SEWAGE DISPOSAL SYSTEM

P 49329

SUBDIVISION Kings Manor LOT 3 ROAD 119²⁵ Queen Street

REPAIR - PURPOSE - SEPTIC SYSTEM HAS FAILED.

P 49329

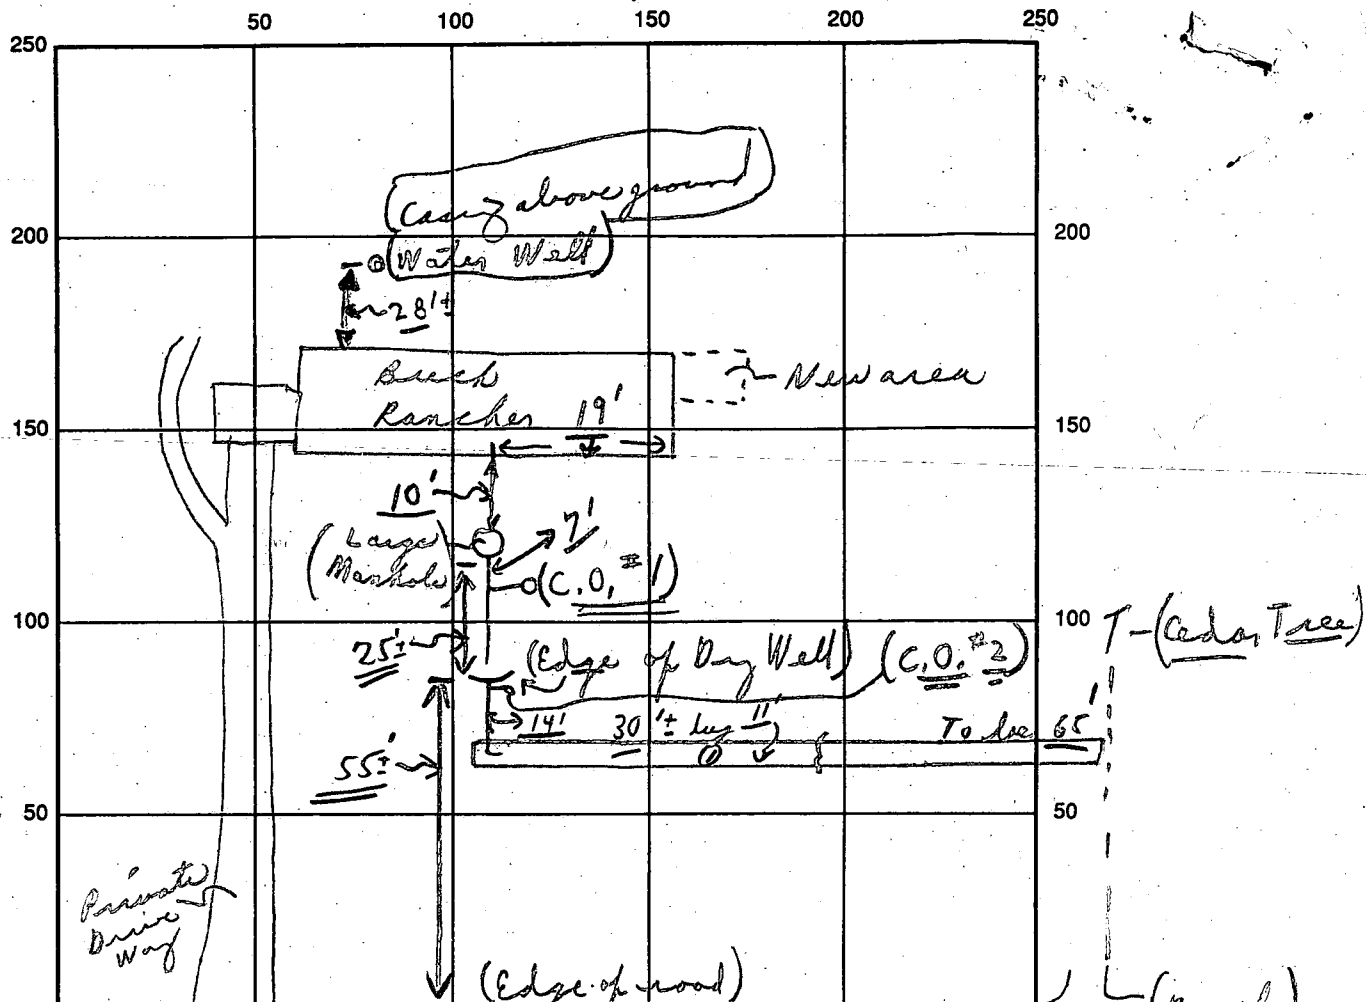
Noted old dry well & add new trench (1) 6' below 1' rd.
(1) Trench 65' ± off existing dry well 2' wide 11' deep
as seen; inlet 15'; 6' ± of stone under pipe, 370' square
of area trench

SEPTIC TANK LEVEL Existing CLEANOUTS New near S.T. & D.W. C.O. #1 ok; T. to be C.O. #2 ✓

DISTRIBUTION BOX LEVEL 1" above old dry well

REMARKS: 5/20/93 Repair 1/2" accomplished; ok to cover as finish; trench cavity due to heavy soil above lighter soil; material on site; Final per previous and above.

LOCATION OF HOUSE

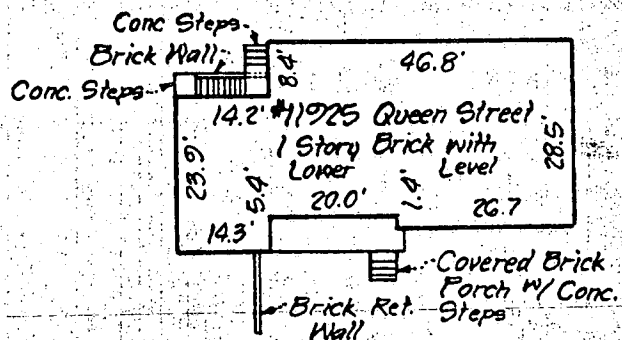
NET OWNER -
GARAGE ADJUSTED
TO MAINTAIN 20'

SETBACK
TO WELL

10/4
WAITING FOR
REVISION
GARAGE TO BE MOVED
(PER MR.)
